### Hurricane Planning Commission Meeting Agenda

June 27, 2024  
6:00 PM

1. FSP24-42: Discussion and consideration of a possible approval of a final site plan for Hurricane Heights Hobby Garages, a storage unit complex located at 700 W 400 N. CSB Development, Applicant. CivilScience - Brandee Walker, Agent.
2. AFP24-10: Discussion and consideration of a possible approval of an amended final plat for Canyons RV Phase 1 Amended and Extended, located at 100 N 2800 W. Western CRE, Applicant. Joby Venuti, Agent.

## STAFF COMMENTS

## C1

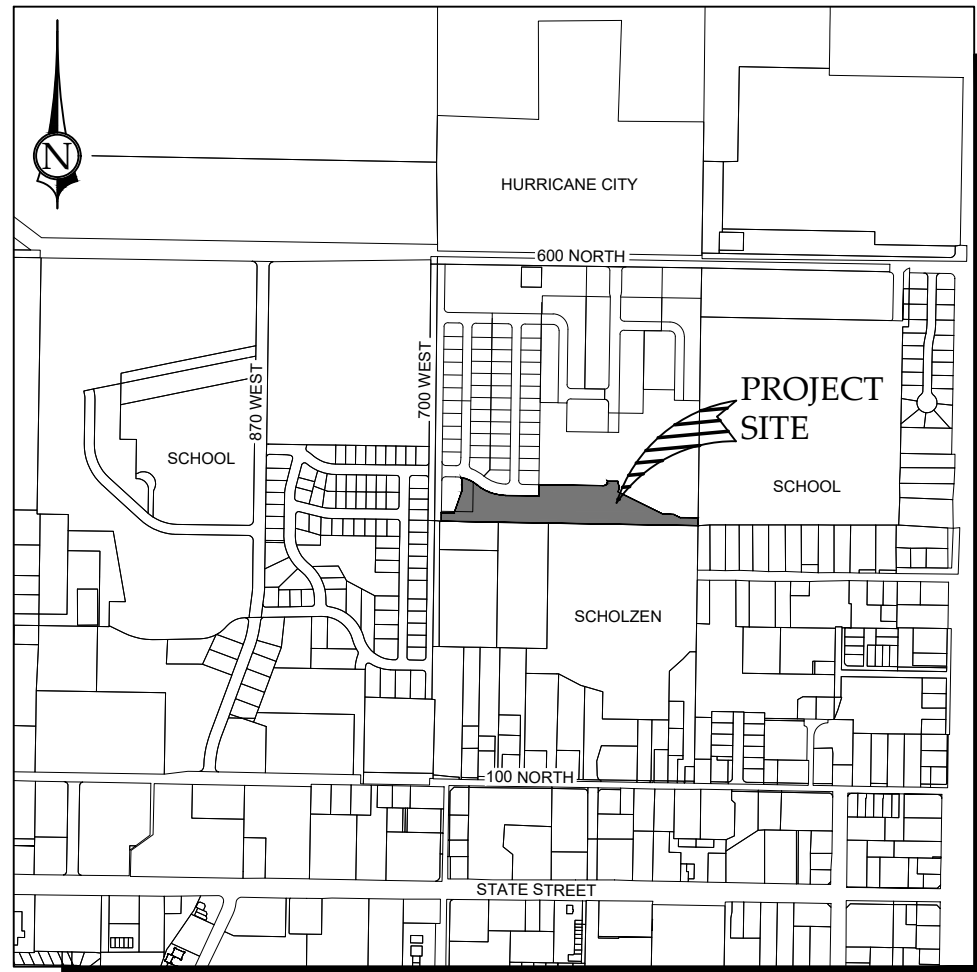
Plans do not show power to the project,

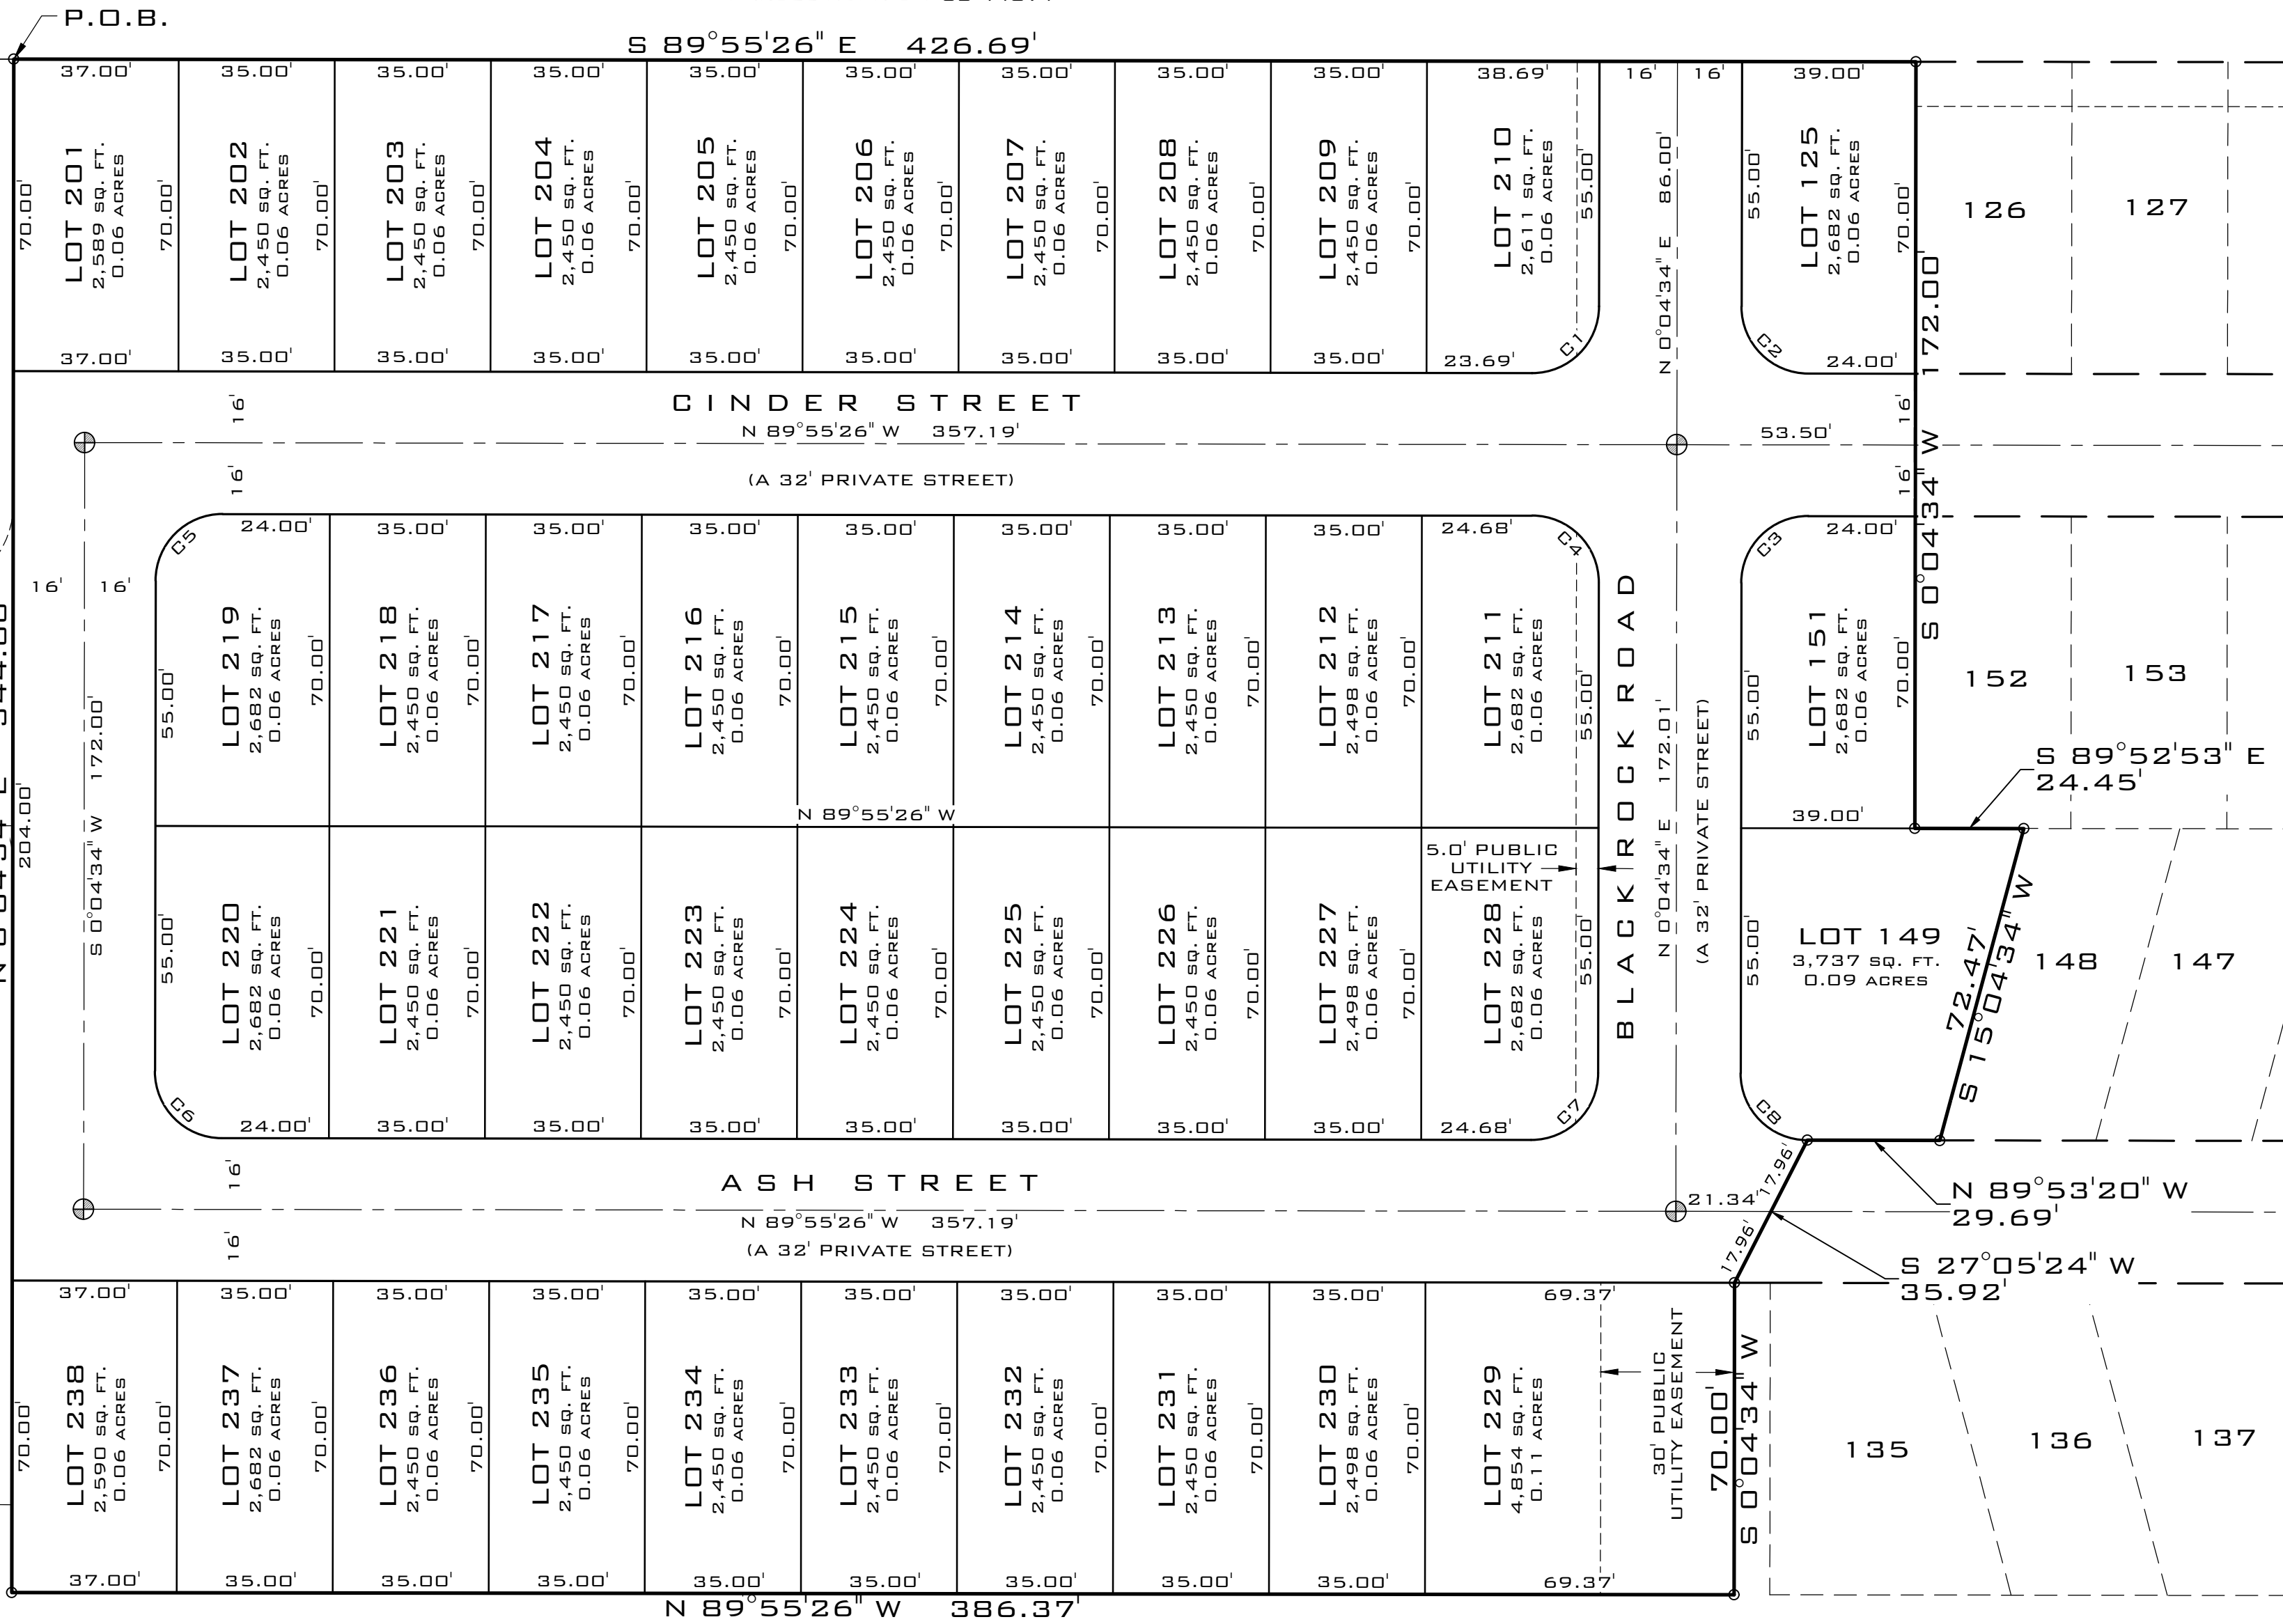
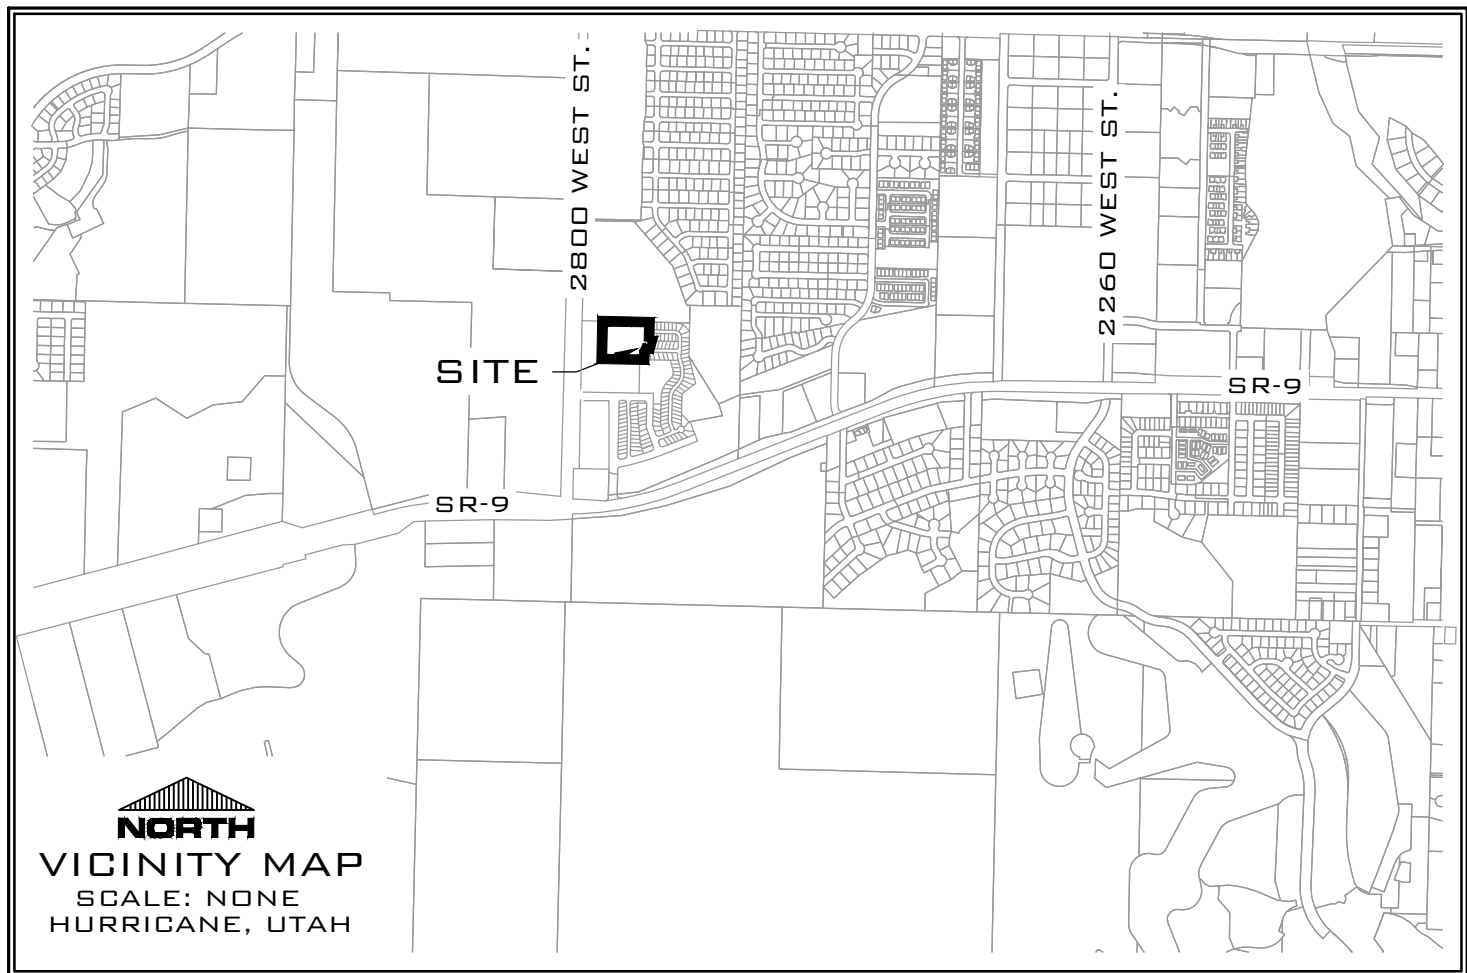
4. The applicant should provide the purpose for the 40' public utility and access easement connecting to 2800 W. The applicant should be aware that 2800 W is a master planned minor arterial roadway and access is strictly controlled along its length. Accesses should line up with the proposed access on the west side of the road.
